CITY of NOVI CITY COUNCIL

SUBJECT: Approval of the "Second Amendment to the Planned Rezoning Overlay (PRO) Agreement Novi Real Estate, LLC" for Medilodge to amend the Exhibit B Document to provide for an additional 34 parking spaces on the north side of the existing development located on the north side of Eleven Mile Road between Beck and Wixom Roads in Section 17. The project consists of the development of a 120 bed, 78,560 square foot convalescent (nursing) home building.

Medilodge of Novi Additional Parking
Preliminary JSP14-61

Re: Medilodge of Novi/Novi Wellness (JSP14-0061)
Wetland Review of the Revised Preliminary Site Plan (PSP15-0068)

REVISED EXHIBIT B

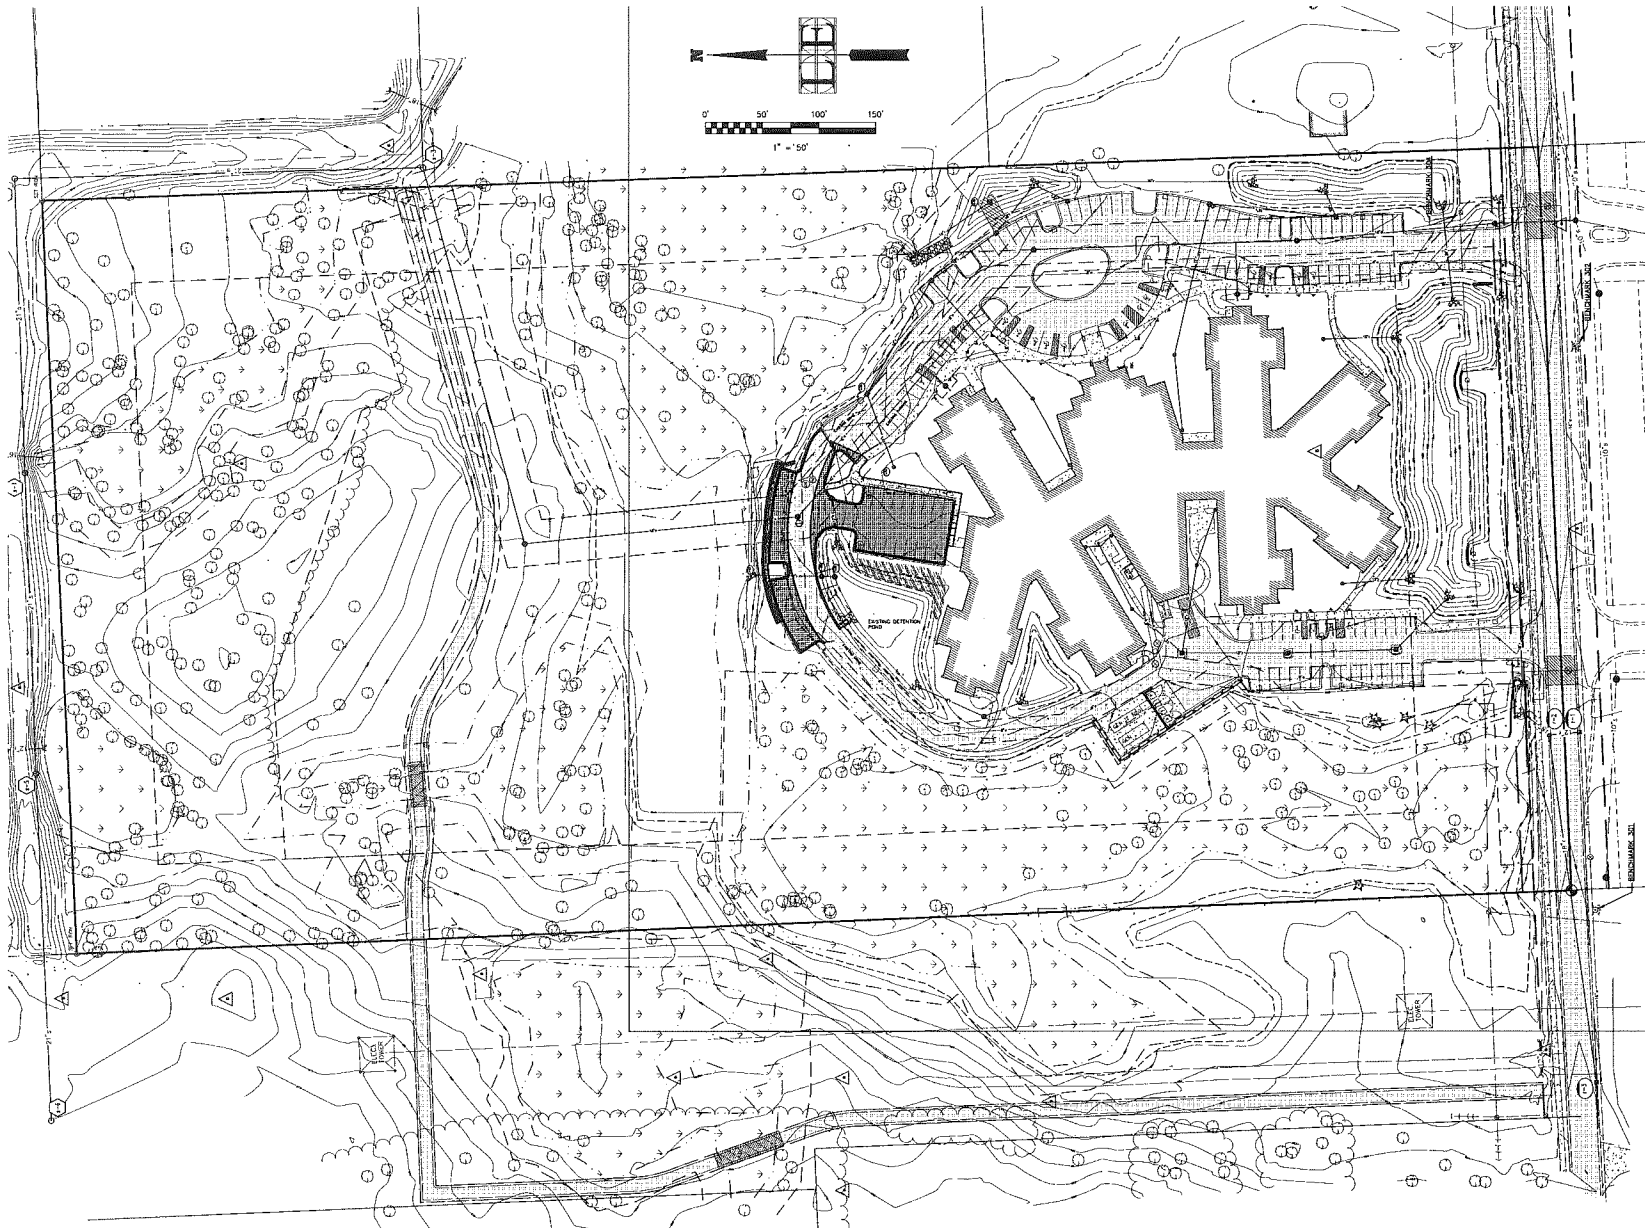
D. Owner/Developer and the City now desire to amend the PRO to reflect the addition of a parking area with 34 additional spaces, as shown on a Revised Exhibit B.

1. Exhibit B hereby amended to add a parking area with 34 parking spaces as shown on the attached revised Exhibit B.
